ITEM FOR PLANNING COMMISSION AGENDA

ADDRESS OF PROPERTY: 2405 Nueces Street and 504 West 24th Street

CASE FOLDER: TP 182241

MEMORANDUM

Exhibit 2

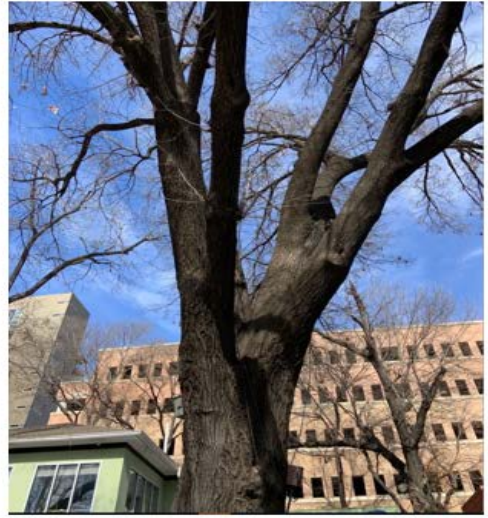
Multiple attachments – all the leaders (scaffold branches) are connected at one place on the trunk. This is inherently a weakness with this tree's main union due to lack of branch taper (Exhibit 2).

Included bark was observed between two unions where stems grow closely together causing weak, under-supported branch angles which may cause branch or total tree failure (Exhibit 3).

Exhibit 5 #911 pecan

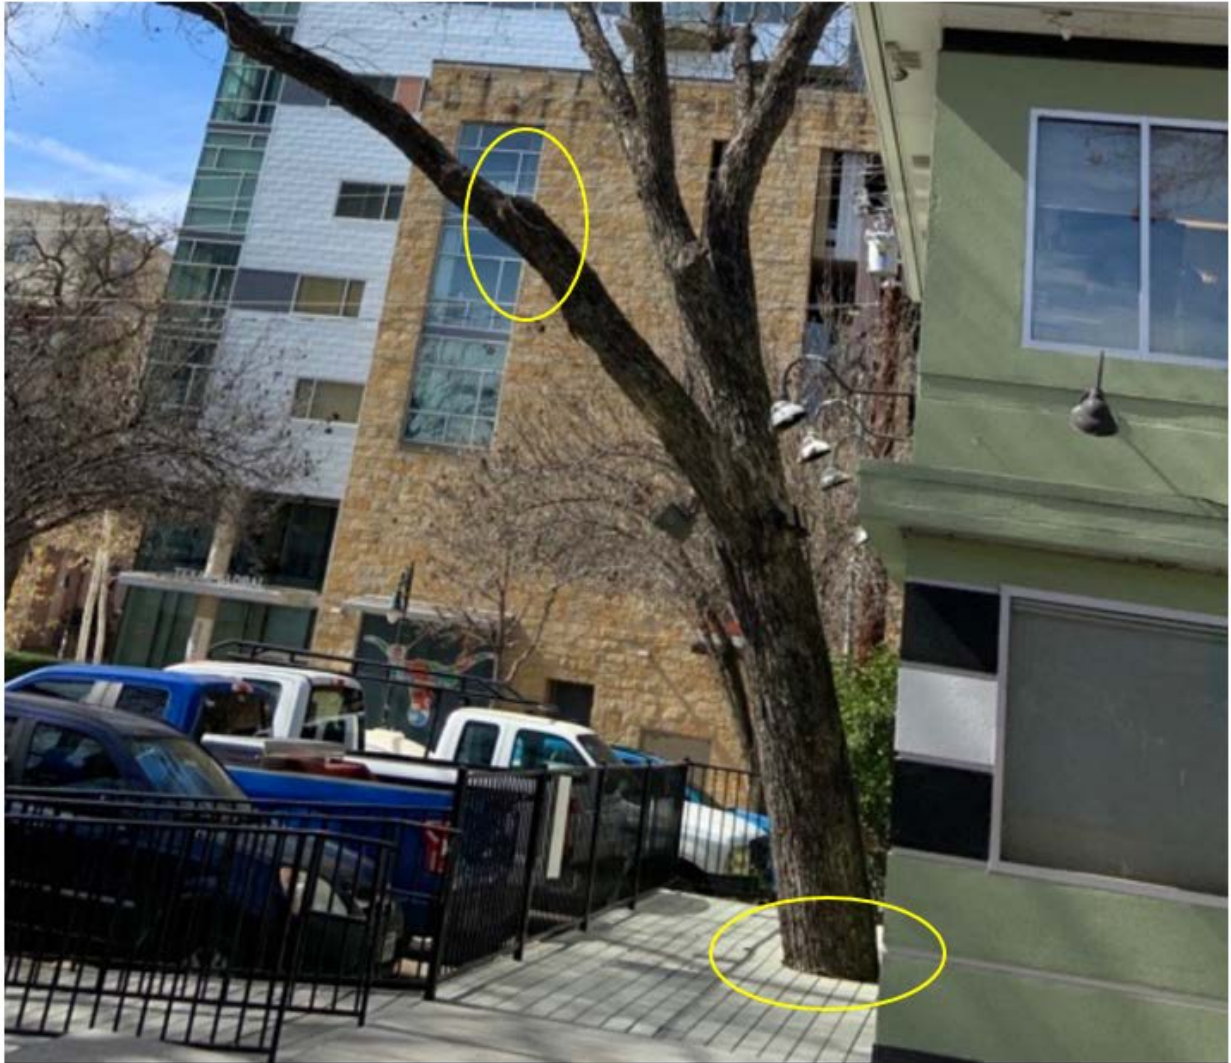
Displays a heightened loading on the stems as a result of the length and excessive end weight of the branches and lack of inner branches. A large cavity was identified in one of the main leaders and hypoxylon canker was observed on live tissue (Exhibits 4 & 5).

Root system is almost entirely covered with disturbed and compacted impervious cover. Evidence that the tree has begun to grow into the decking resulting in girdling the cambium layer of tree (Exhibit 5).

Large cavity in major leader; growing in to decking – girdling trunk cambium layer

EXHIBIT B: Developable Area Impact

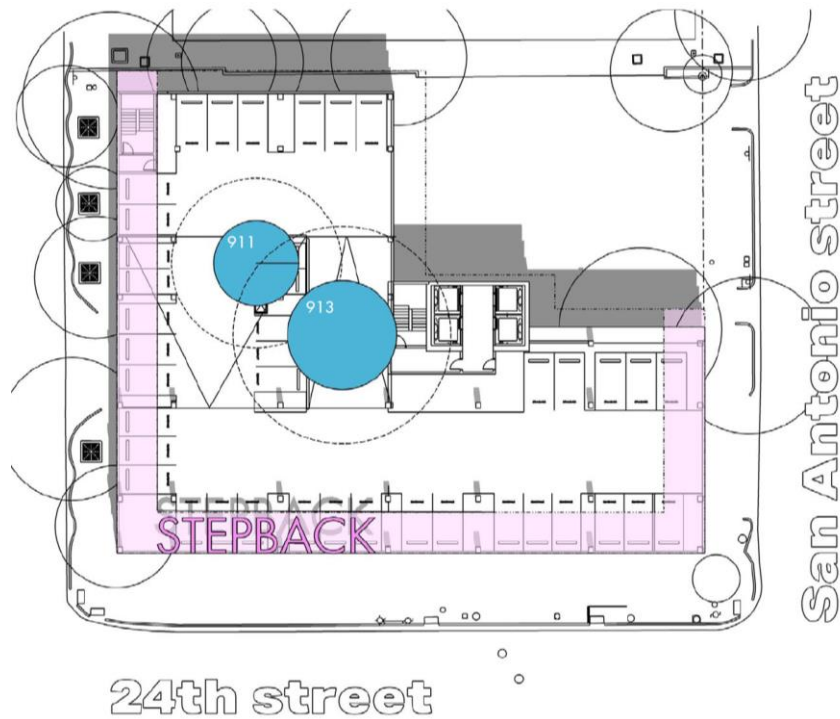
The trees requested for removal on the site are located in the middle of the site. Given their location and existing canopy, the trees impact approximately 25% of the site.

The onsite trees are located on the only portion of the site that is wide enough to support a ramp for

structured parking, thus severely impacting the reasonable use of the Property for a residential tower. Leaving the trees will prohibit the ability to provide structured parking and results in a 50% reduction in gross square feet of developable area, see Exhibit B below. Further, Exhibit C, below, illustrates different design layouts assuming the trees remain, showing that even if there was a way to address the impact to parking, keeping the trees renders the site unable to provide a working building floorplates or insufficient natural light for the health of the tree.

Exhibit C: Considered Building Layouts

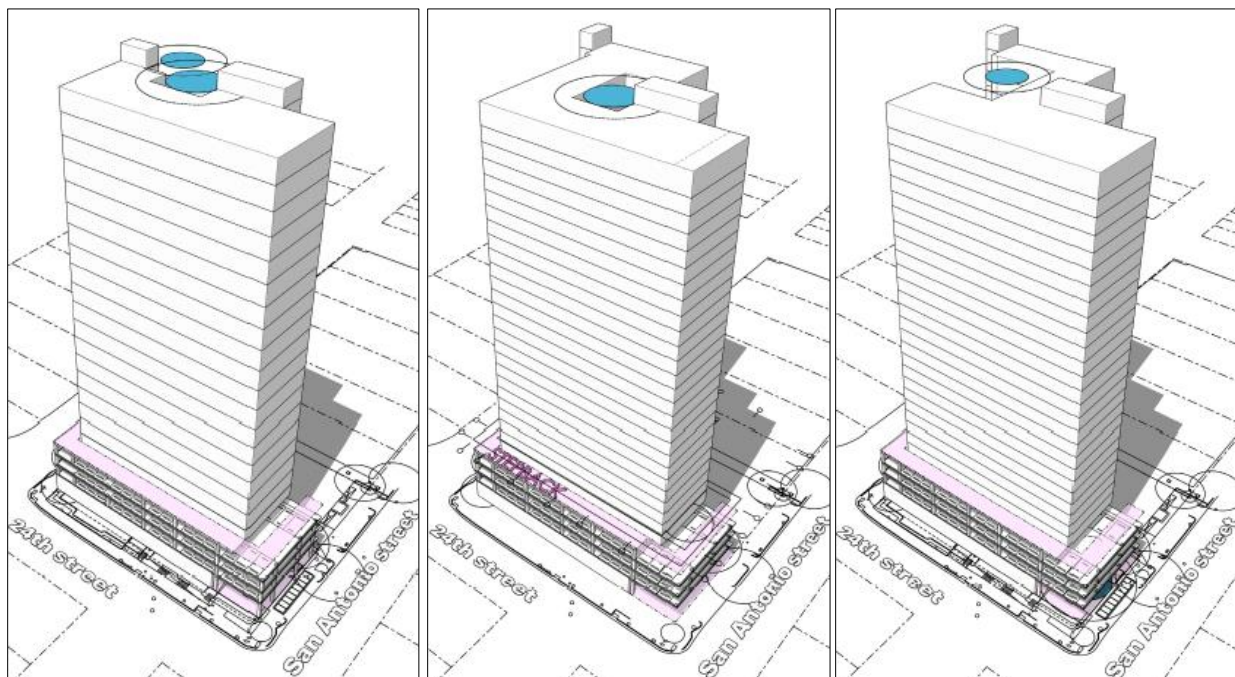
Given the (a) stepback constraint; (b) location of the trees; (c) limited acreage of the site; and (d) the tree survey report prepared by Wuest Group, we respectfully request the removal of trees 911 and 913.

EXHIBIT B: Developable Area Impact

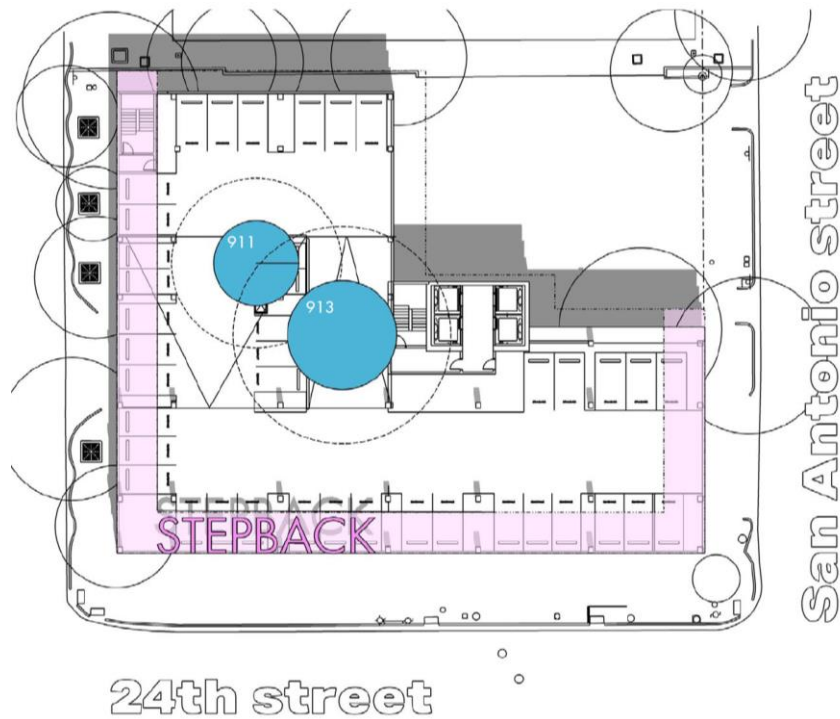
The trees requested for removal on the site are located in the middle of the site. Given their location and existing canopy, the trees impact approximately 25% of the site.

The onsite trees are located on the only portion of the site that is wide enough to support a ramp for

structured parking, thus severely impacting the reasonable use of the Property for a residential tower. Leaving the trees will prohibit the ability to provide structured parking and results in a 50% reduction in gross square feet of developable area, see Exhibit B below. Further, Exhibit C, below, illustrates different design layouts assuming the trees remain, showing that even if there was a way to address the impact to parking, keeping the trees renders the site unable to provide a working building floorplates or insufficient natural light for the health of the tree.

Exhibit C: Considered Building Layouts

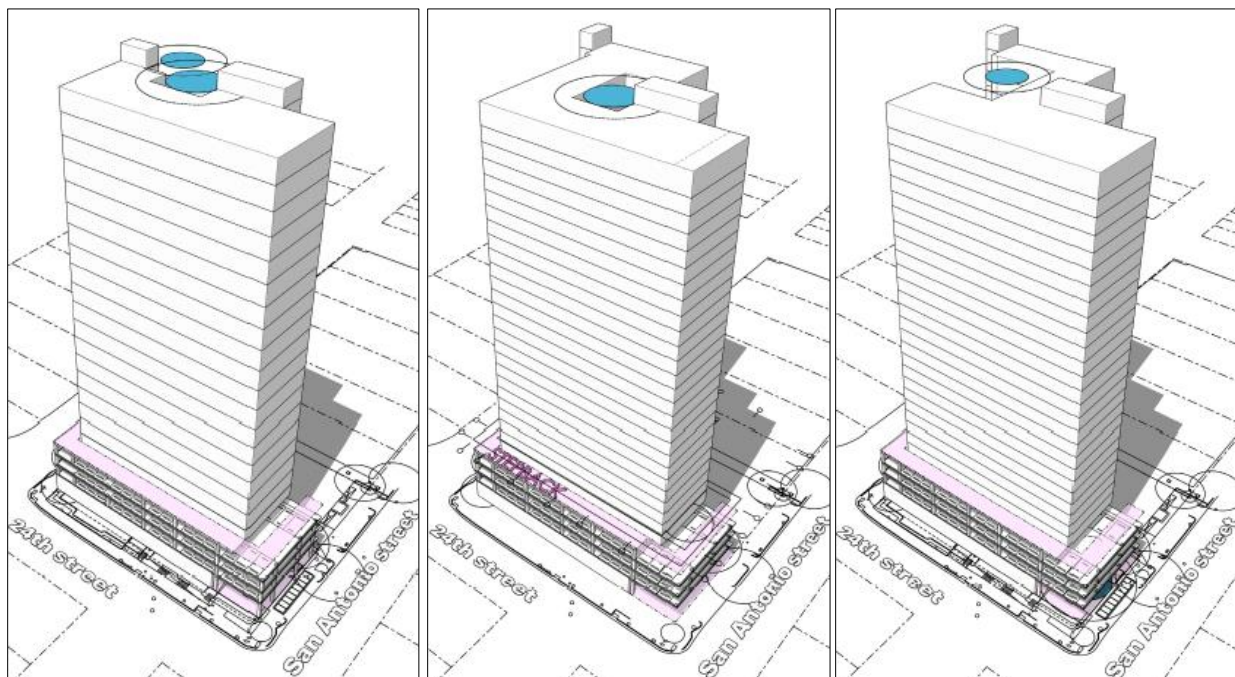
Given the (a) stepback constraint; (b) location of the trees; (c) limited acreage of the site; and (d) the tree survey report prepared by Wuest Group, we respectfully request the removal of trees 911 and 913.
